AIR RECEIVER Endorsement.

Shipbuilders: Messrs. Chantiers et Ateliers de St Nazaire Trawler for
No. Mr. Hurel

Air Receiver No.

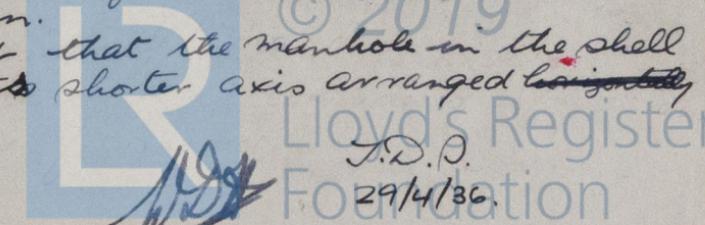
It is submitted that the plan of riveted
air receiver merits approval for a working pressure of 25 kgs
per sq. cm., provided the air receiver be constructed under

the usual conditions of survey and testing.

+ the thickness of the dished end plates be not less than 29 mm.
It is concluded that the radii of the dished ends are as
now indicated on the plan.

It should be pointed out that the manhole on the shell
Return plan! should have its shorter axis arranged longitudinally
Retain copy!
